Sitka Seawalk Phase II (SFHWY00312) Public Comments - Personal information is redacted for those that requested their name not be associated with their comment.

SUBJECT: SFHWY00312 Sitka
Seawalk Phase II
Sitka Trail Works
Comment

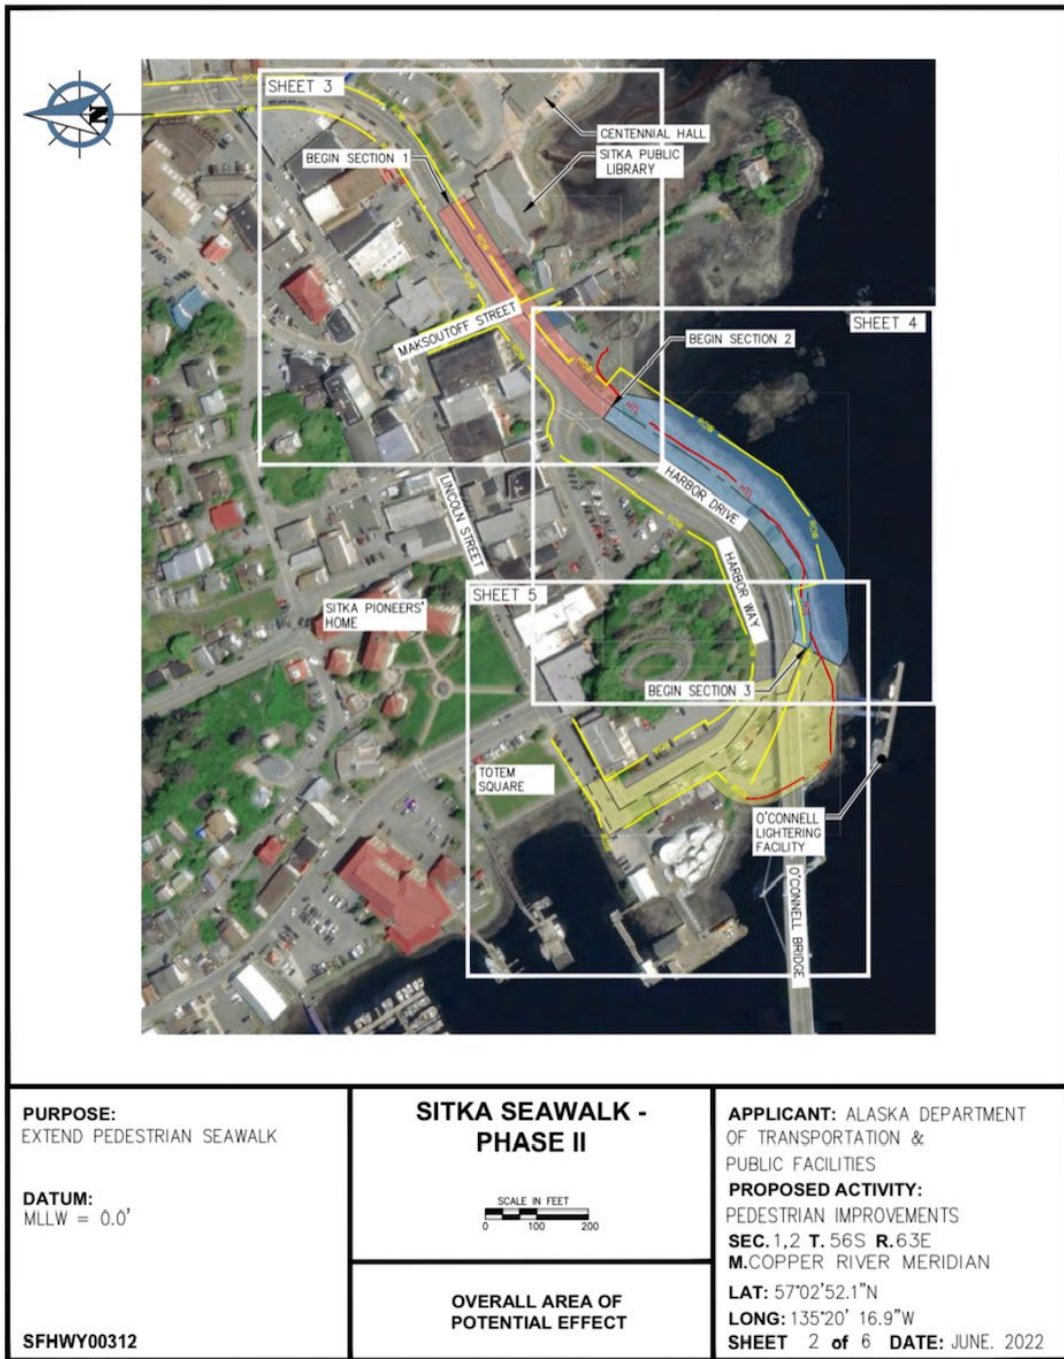
Nice to hear from you and thank you for this graphic. A key would be most helpful to share with the members of the Club.

I see now the yellow lines in this public notice graphic are the ROW. The red overlay over our property in your public notice is apparently a ROW take. Is this correct? If it is not, according to the narrative in your email, the graphics must be in error. None of the graphics in this public notice have keys and the shading, I believe, is misleading.

While the surveyors are out collecting topographic data, could we please stake out the ROW in front of our cottage to define the State's ownership?

Hi Anne, Good questions and thank you. The drawing I sent earlier is the correct depiction of the ROW and the proposed improvements in front of the cottage. Please refer back to that drawing as the correct situation. The project does not require additional ROW along Harbor Drive. The scoping drawing you attached below was developed for agency scoping and it shows the broad "area of potential affect" and was not intended to show the precise project footprint. It's easy to see the confusion and we will correct this in future versions. We are just starting the public involvement process so you are a little further ahead of us. There will be a public comment period and most likely an open house sometime in the November-December time frame this year. If you have any ideas how to best involve the public, we'd love to hear your suggestions.

Attachment: A google-earth image of part of the Segment-2 area, with red dots showing existing 8-foot width pedestrian access.

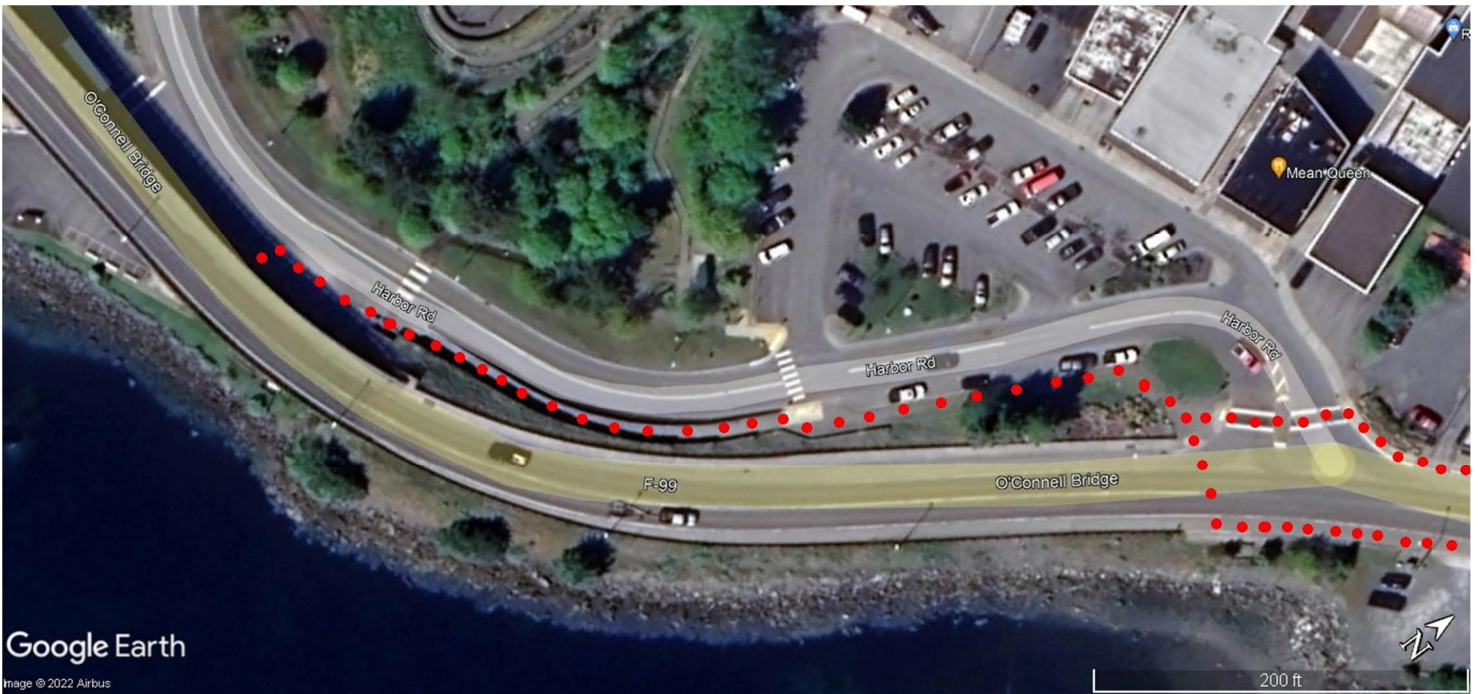
Existing 8-foot walkway from the lightening facility to and beyond the foot of the bridge.

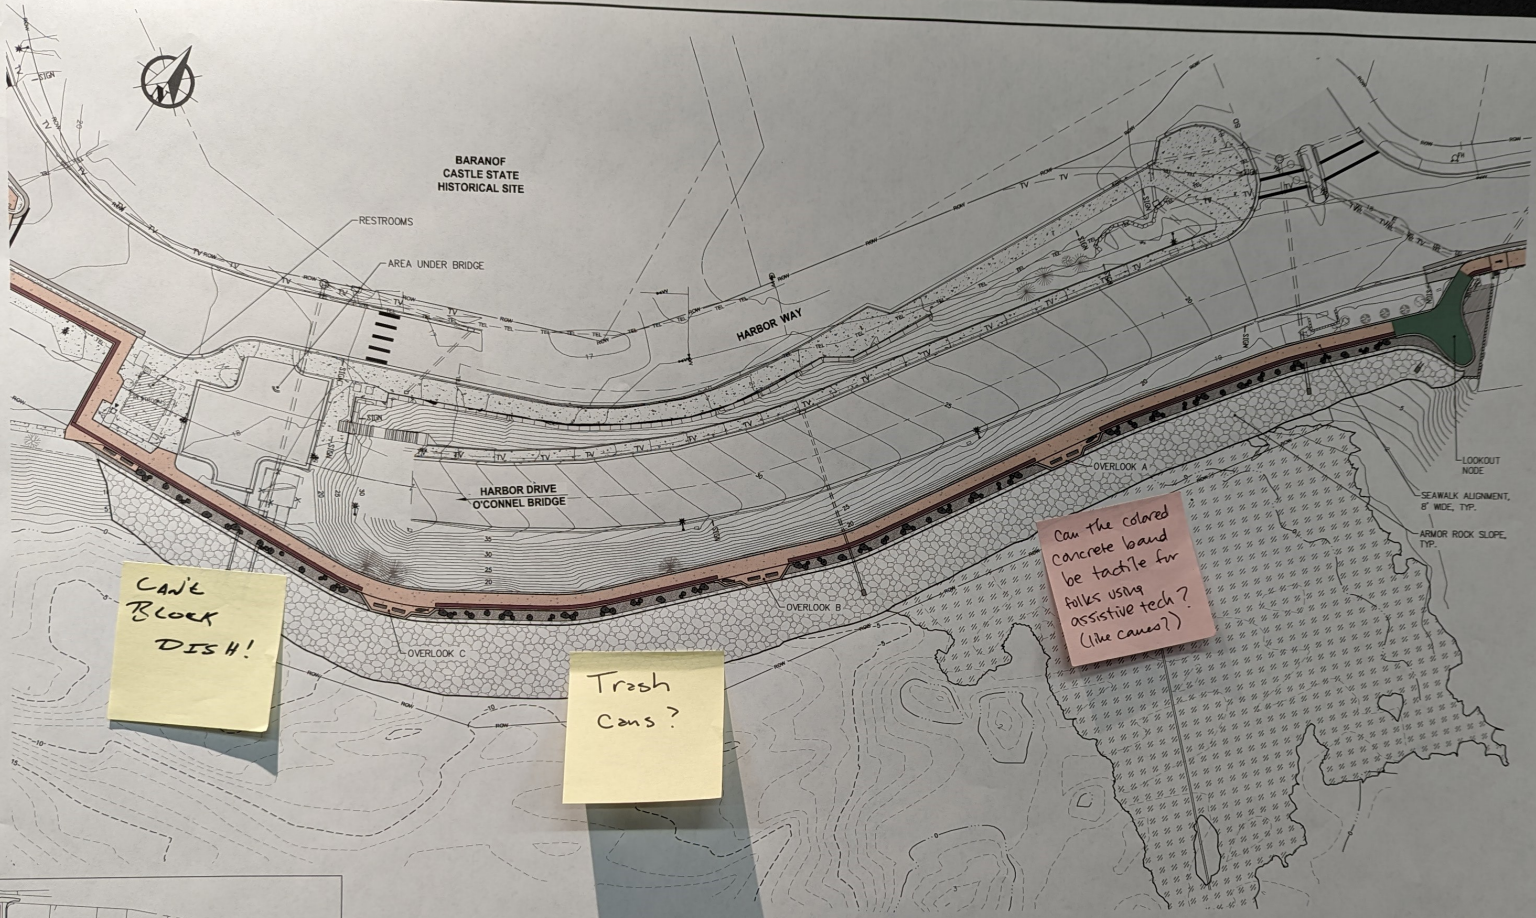
CAN'T
BLOCK
DISH!

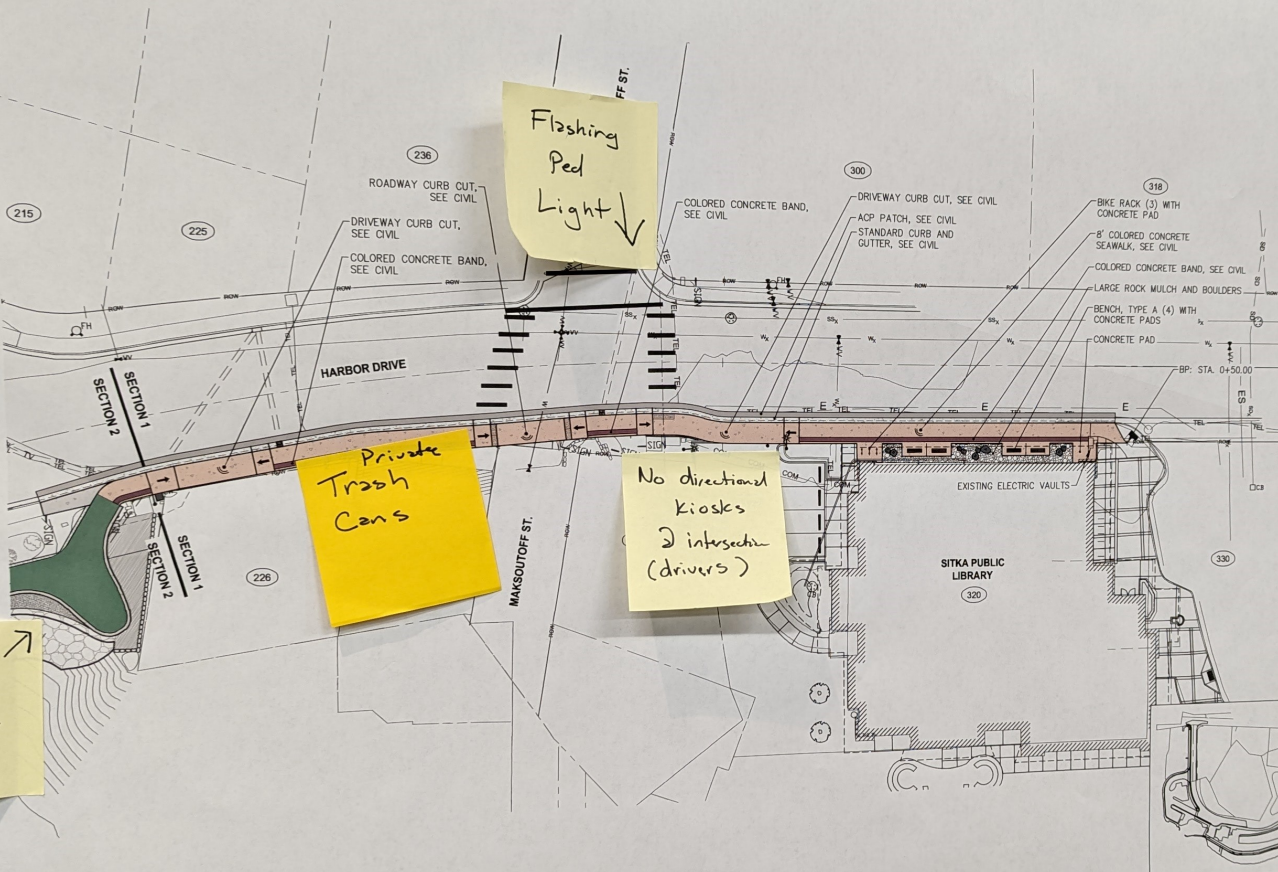
Flashing Ped Light ↓

Private Trash Cans
